Seismic Walkdown Checklist (SWC)

Equipment ID No. Q1R17B002 Equip. Class¹ 1

Equipment Description MCC 1B

Location: Bldg. AUXILIARY Floor El. 121 Room, Area 209

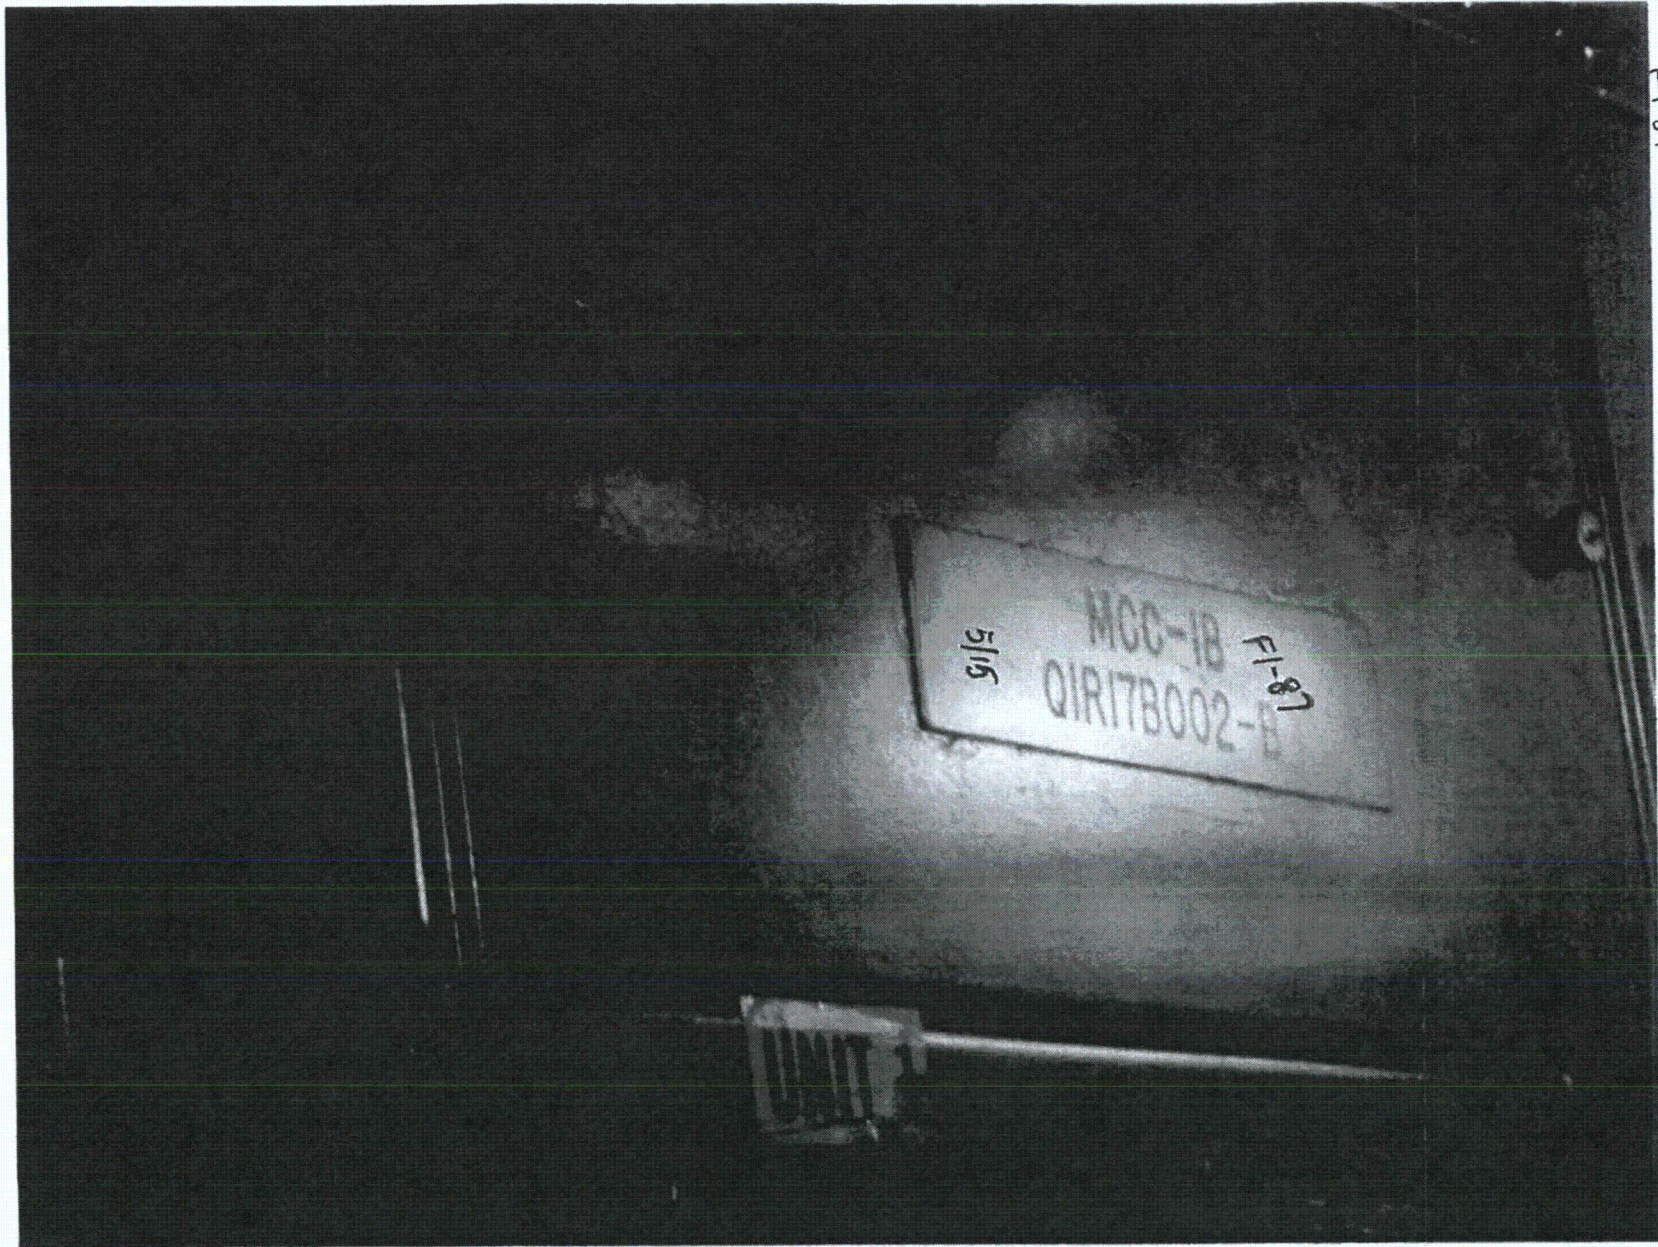
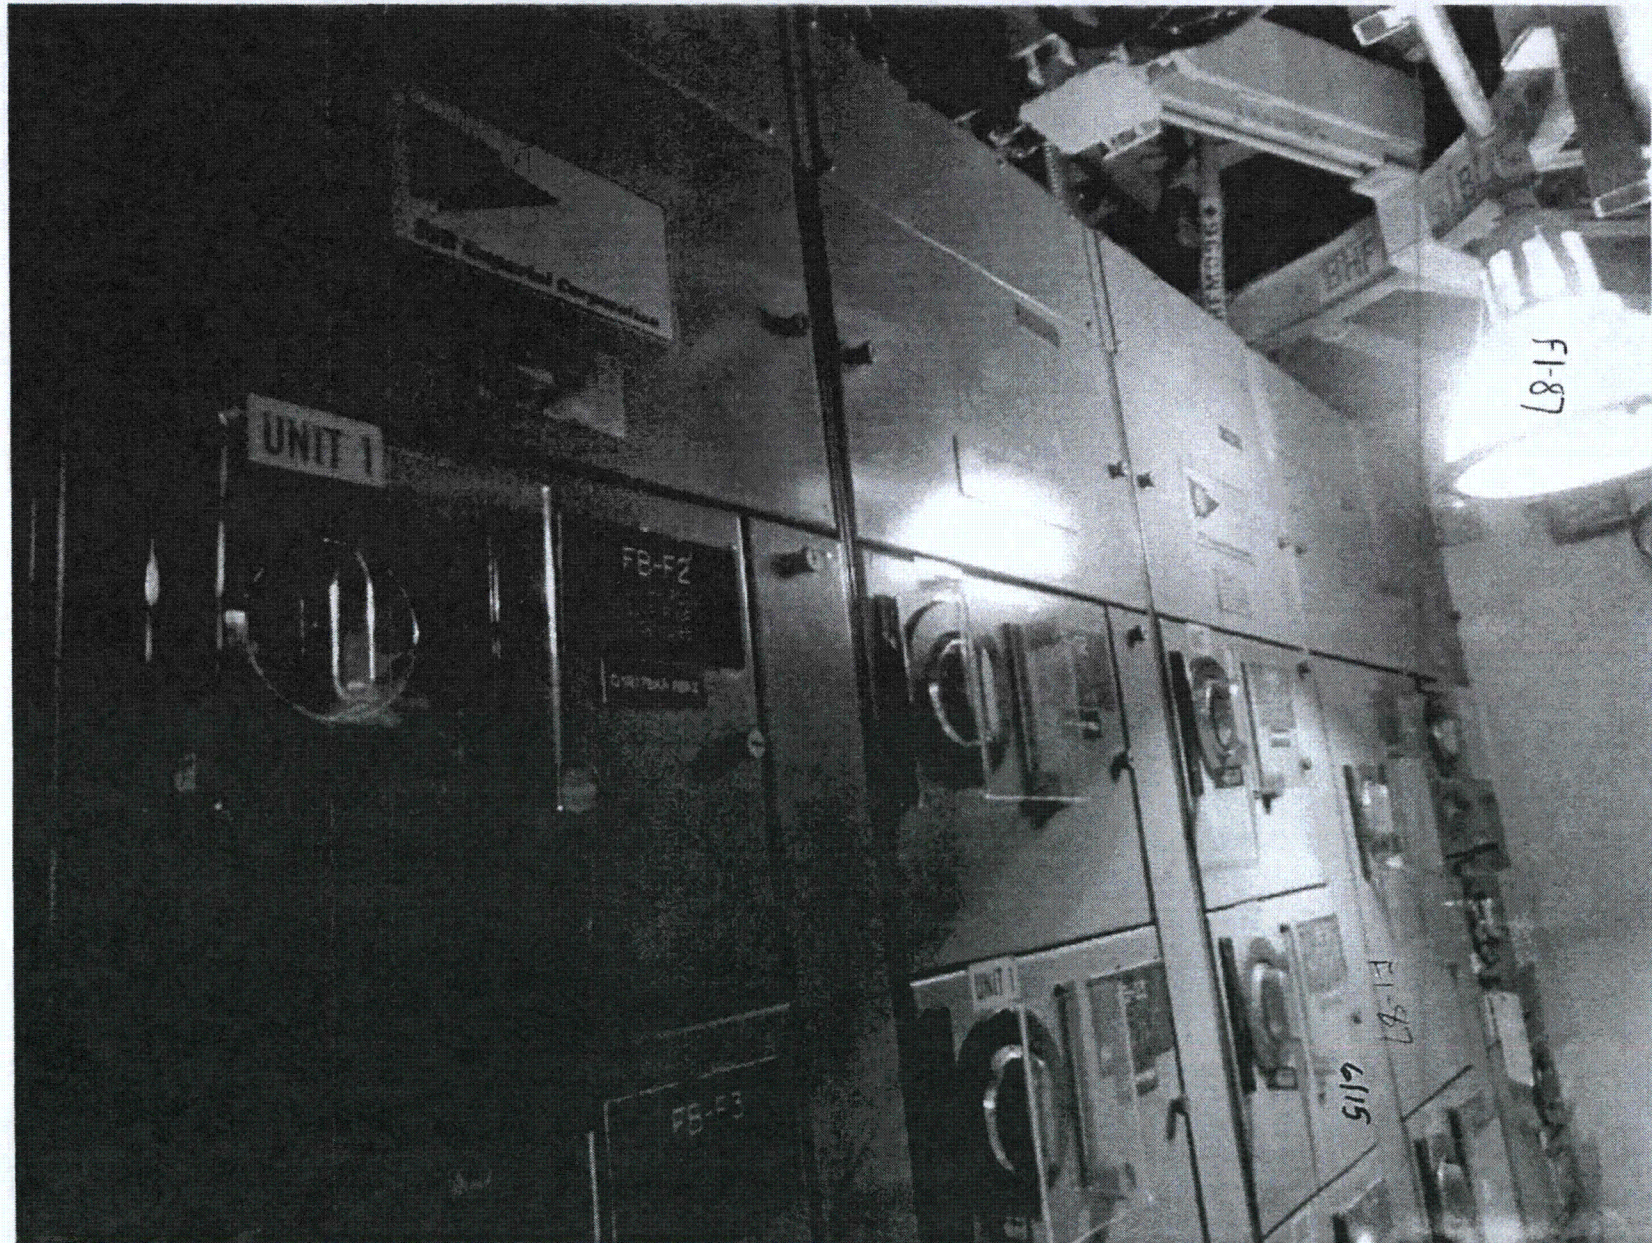
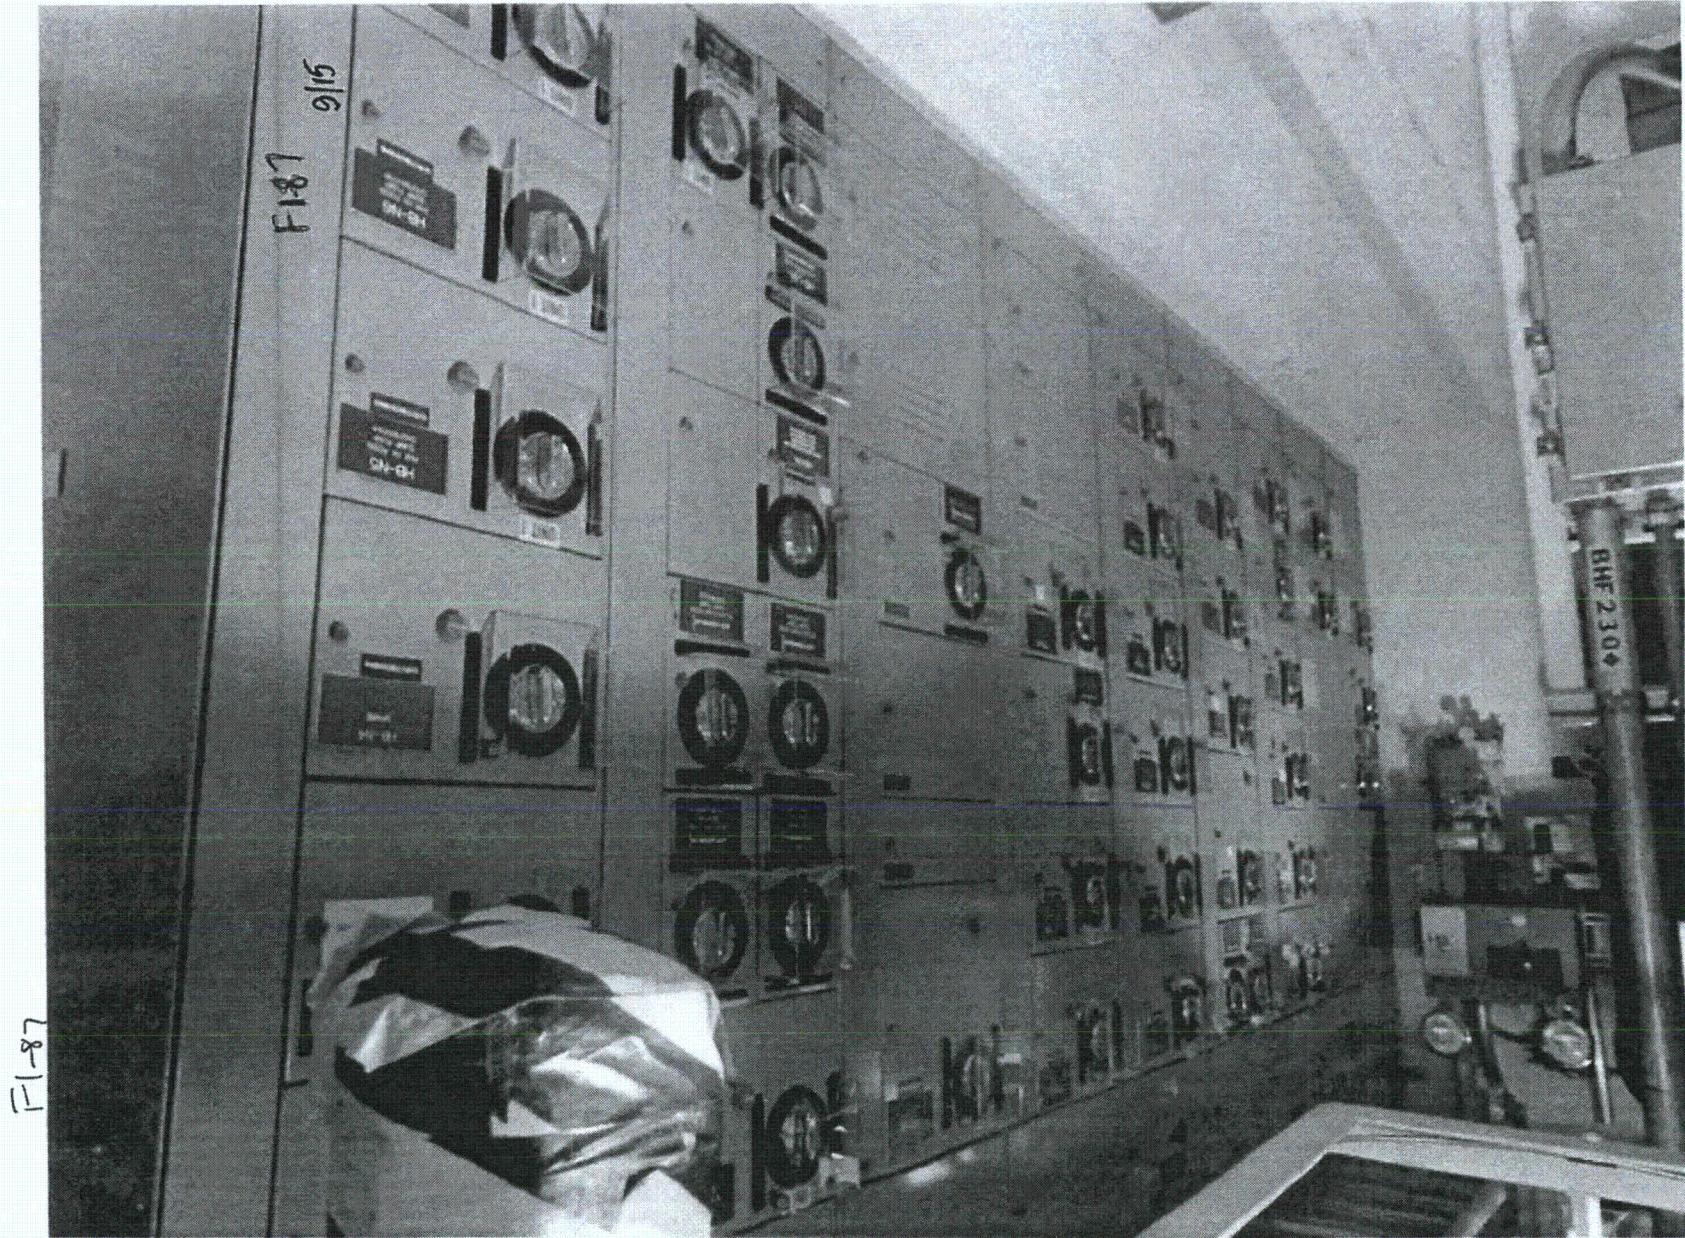
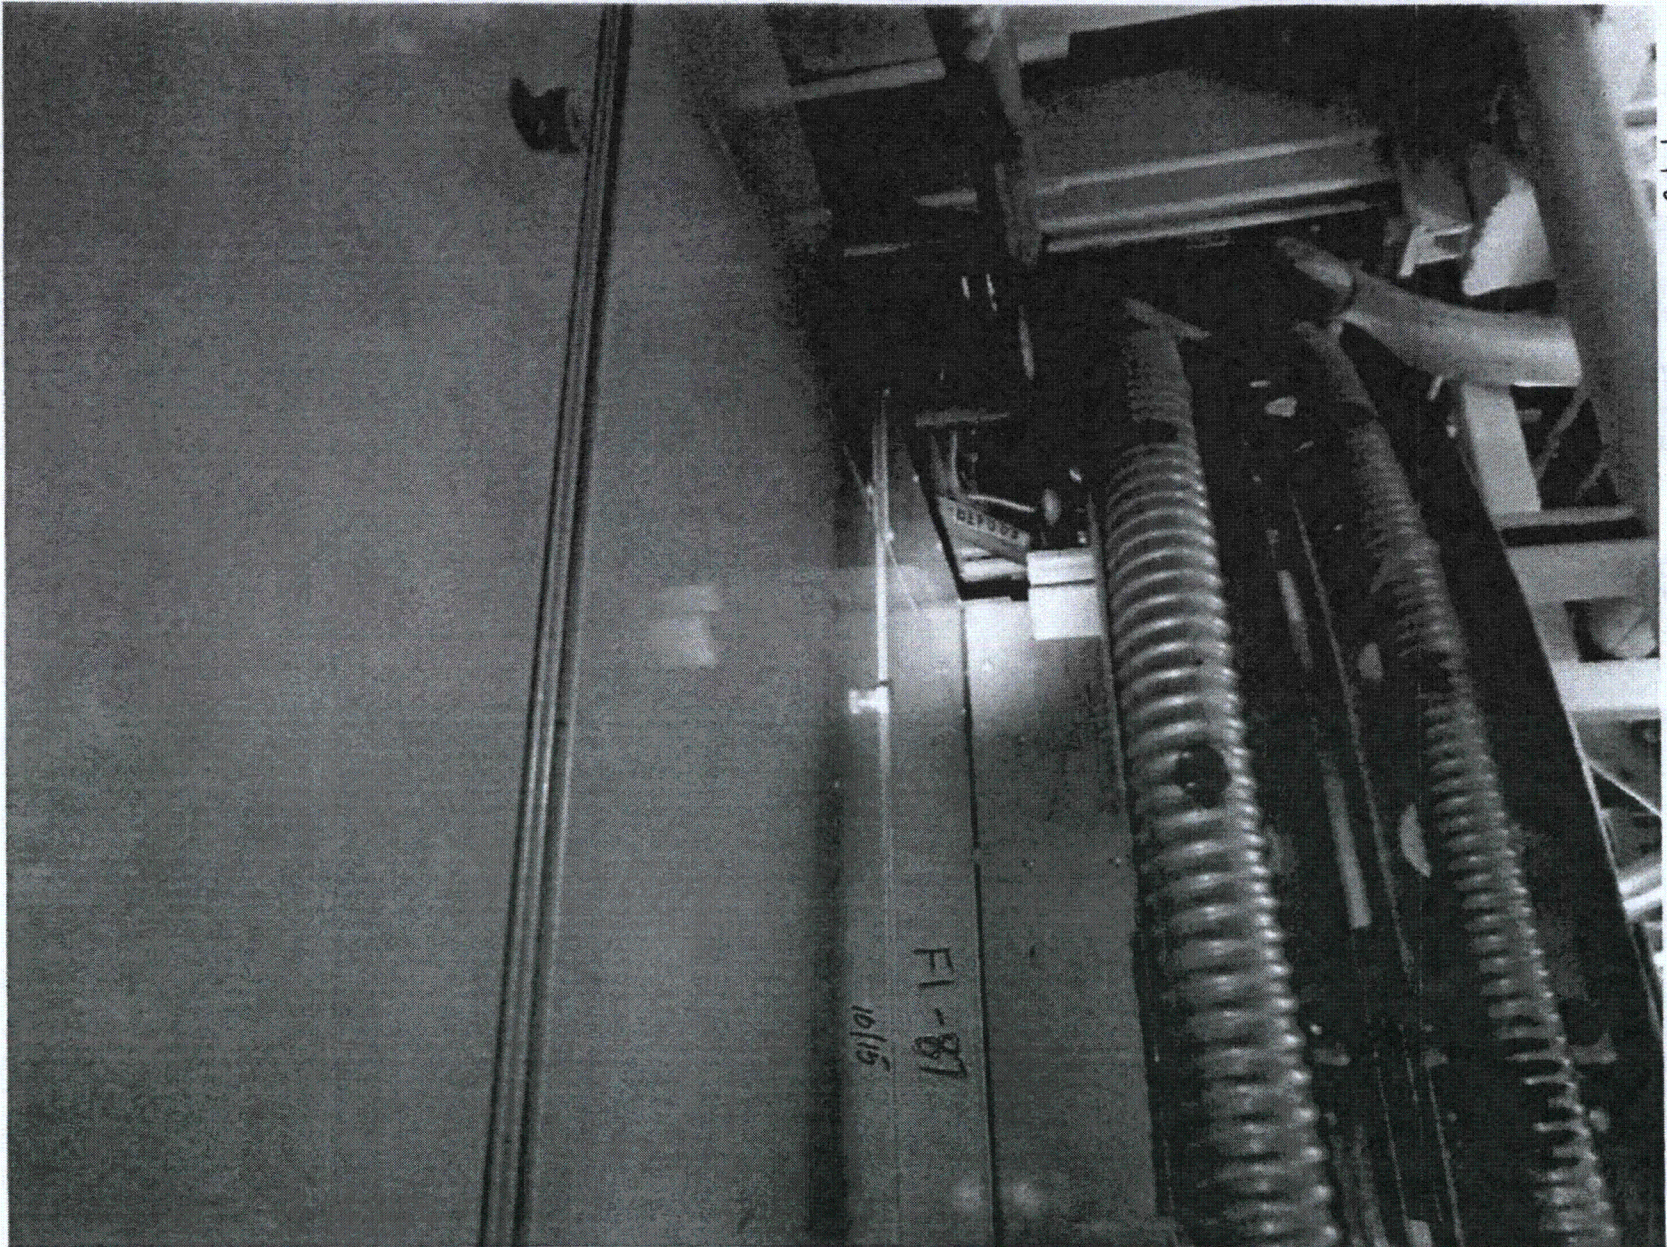
1. L CLIPS NOTED TO EXIST NEAR TOP OF MCC ON THE SOUTH WALL TO PREVENT E-W MOVEMENT. OK.
2. TRANSFORMER N1R17E001 WAS FOUND BOLTED TO MCC, ∴ OK
3. DUE TO THE MCC LOCATION IN A CONFIGURATION CONTROL AREA, COULD NOT VERIFY CONNECTION OF EAST AND WEST MCC ELEMENTS. SEE PHOTOS, PAGES 10 & 11. A BAR EXISTS THAT PROBABLY PROVIDES THE REQ'D TIE, BUT BOLTS ON THE TOP OF THE MCC COULD NOT BE SEEN.

CONNECTION AT TOP OF MCC IS CONFIRMED. A BAR IS WELD TO THE WEST END AND BOLTED AT EAST END TO CONNECT FRONT AND BACK MCC TOGETHER.
